# Improved Transmission Selection

# Congestion Management and Transmission Selection

# Summary of Changes

Figure 8-9—Forwarding Process functions

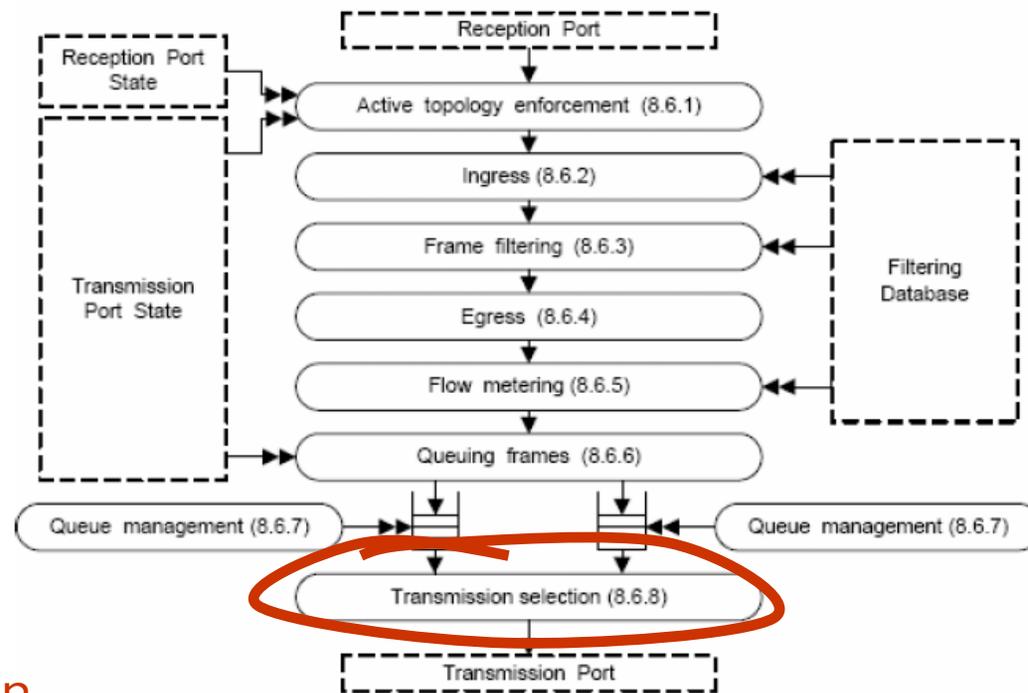
Add new optional transmission selection mechanism in 8.6.8
